N11 - Brewery Road Improvement Scheme

Public Consultation – Report on Submissions

Client: Dún Laoghaire-Rathdown
County Council

Client:	Dun Laoghaire Rathdown County Council
Project:	N11 Brewery Road / St. Brigid's Church Road Junction Safety Improvements
Scale:	1:250 @ A0
Drawn By:	CP
Checked By:	CAB
Drawn/Checked:	Preliminary
Drawn No.:	13_066A_3102

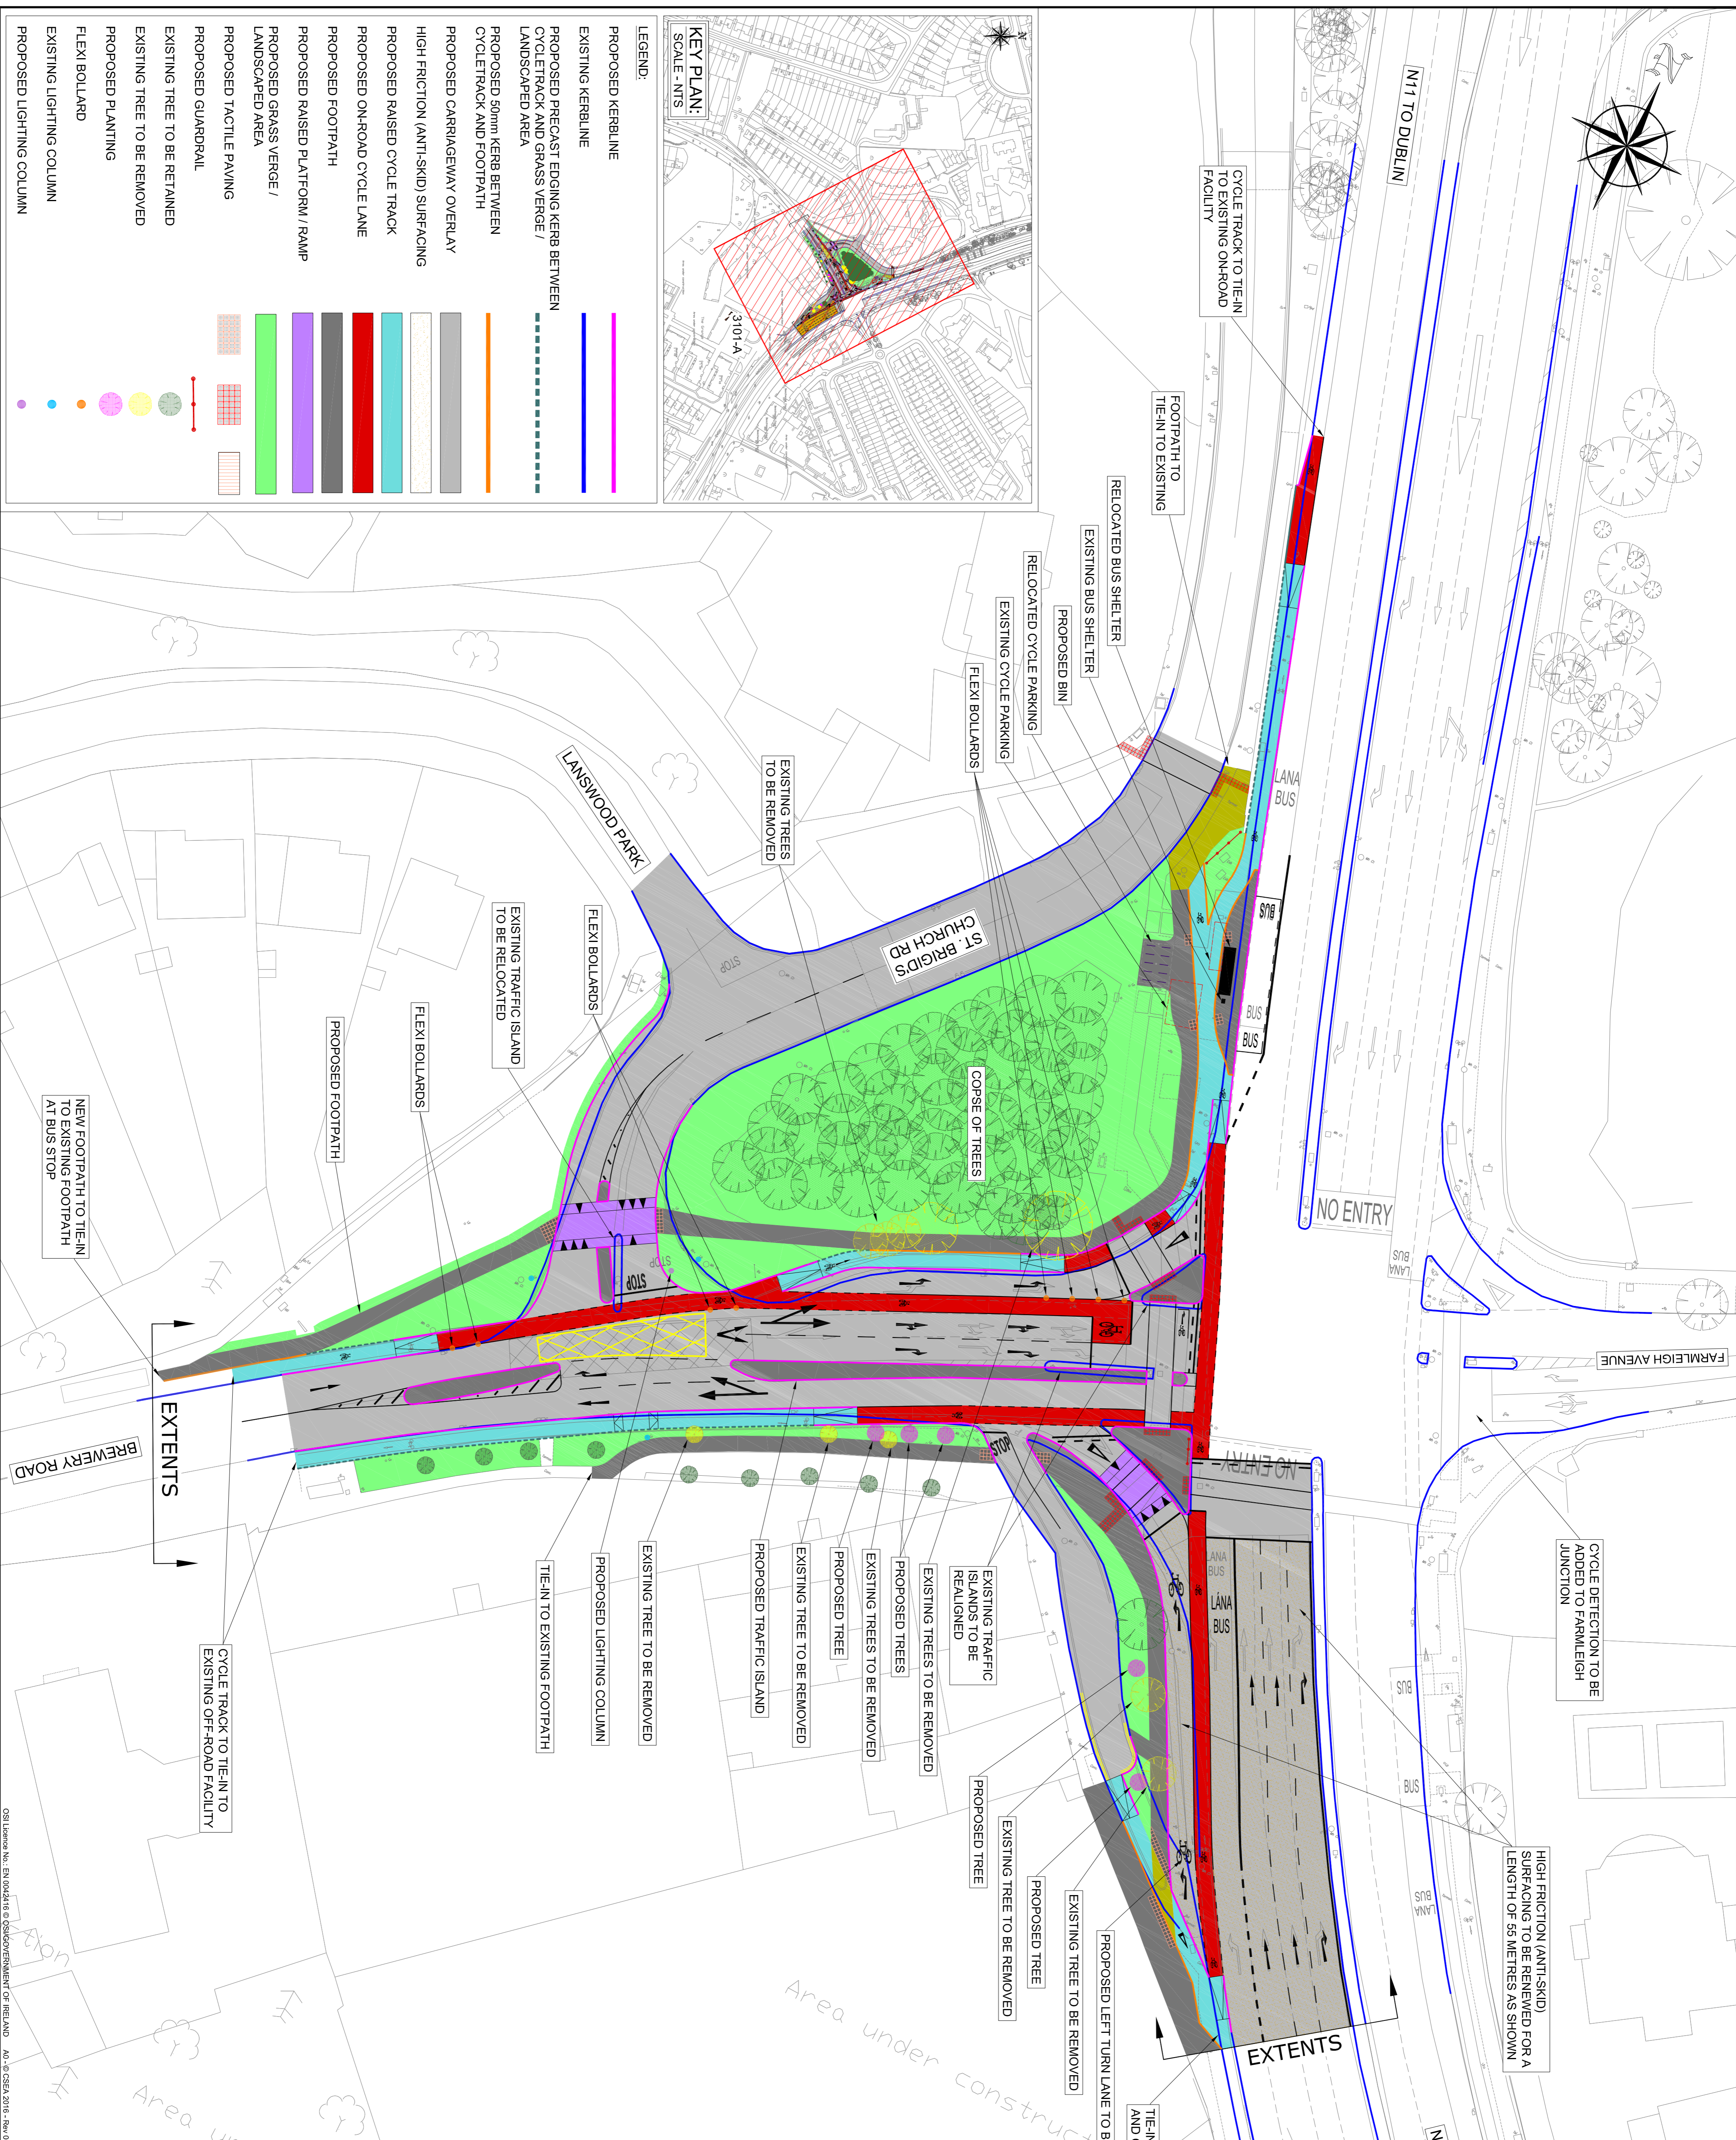
The map shows no changes at Farmleigh Avenue apart from a Cycle Detection unit. Are proposed new pedestrian lights on the north side of the junction are still part of the plan as they are not shown on the updated map.

The drawing indicates that there will be 4 to 5 less trees at the junction after the scheme. The number of trees at the junction must be maintained.

The extent of the works proposed under this current scheme is as shown on the display drawing. The works proposed under the earlier scheme (Stillorgan Village to Brewery Road) will be completed at a later date should funding come available.

Removal of the slip lane into Farmleigh, and replacement of the existing staggered pedestrian signals with one crossing are not included in the current scheme. Construction of a pedestrian crossing across the N11 (northern arm of the junction) is also not included in the current scheme, however, the current works will facilitate their inclusion at a later date. Both of these items are tied to each other, and would involve significant additional works which cannot be funded at this time.

The display drawing showed 5No. trees are to be removed from the south west corner of the junction, with 4No. replacement trees proposed. The recommended scheme replaces the 5No. removed trees.

- The addition of a 'stay left-to-go-right' road marking will be added to the mouth of Farmleigh Avenue with its own cycle detector.
- The addition of a cycle link to the small access road from the N11.
- The addition of a cycle link to St Brigid's Church Road from the cycletrack at the bus stop on the N11.
- Trees that are removed due to the works will be replaced.
